Wednesday, 9/6/2006 3:43:59 PM Date Kim Johnston **Process Sheet** : LUG BRACKET **Drawing Name** : CU-DAR001 Dart Helicopters Services Customer Mh 06.0906 Job Number : 28435 : 10364 **Estimate Number Part Number** : D3046041 :NIA P.O. Number : D3046 REV. A UNDER REVIEW S.O. No. : N/A **Drawing Number** : 9/6/2006 This Issue : N/A Project Number Prsht Rev. · MA : SMALL /MED FAB Type **Drawing Revision** First Issue : NIA : 27466 Material **Previous Run** Each : 9/13/2006 **Due Date** Written By Checked & Approved By New issue SM/EC Comment **Additional Product** Job Number: **Description:** Seq. #: Machine Or Operation: D30461 Lug Bracket 1.0 Comment: Qty.: 6.0000 Each(s) 1.0000 Each(s)/Unit Total: LUG BRACKET Description Batch Qty Part Number Orpyac Lug Bracket D3046-1 2.0 D30463 Lug Bracket Comment: Qty.: 1.0000 Each(s)/Unit Total: 6.0000 Each(s) LUG BRACKET Pick: Description Batch Qty Part Number B 28450 N/A D3046-3 (Bell P/N: 206-052-106-1) Lug Bracket 5R + 515 Return Authorization # Bell original batch# SMALL & MEDIUM FAB RESOURCE 1 3.0 SMALL FAB 1 Comment: SMALL & MEDIUM FAB RESOURCE 1 MF. 06/09/11/ 5AD 06:09:11 @ 1- Tranfer drill holes from D3046-3 into D3046-1 as per Dwg D3

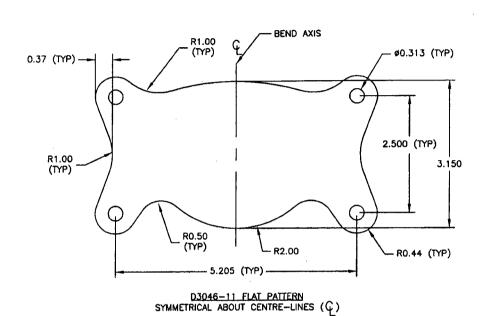
NCR:		. Wo	ORK OR	DER NON-CONFORMANCE	E (NCR)			
	STEP	Description of NC Section A	Corrective Action Section B			Verification	Approval	
DATE			Initial Chief Eng	Action Description Chief Eng	Sign & Date	Section C	Approval Chief Eng	Approval QC Inspector
06-G12	5.0	D3046-3 for installation onto D3046-1 lus. The -3 broke on the end.	B	fort is surp. Zestray.	.12		8	069.0
		Lug Ass'y Obesn't fit	05117		06.05/12	06-05-12	a	05676
C G. L	5.0	anto stube SAMPle, due to the contour. fit of the 03046-3 Bellbart and the thickness by i'll up of the 030461	18 agrin	clesign, so part properly mates with skill tube.	06.67.17.	16.09.12	BERLE	02-09-12
				41.
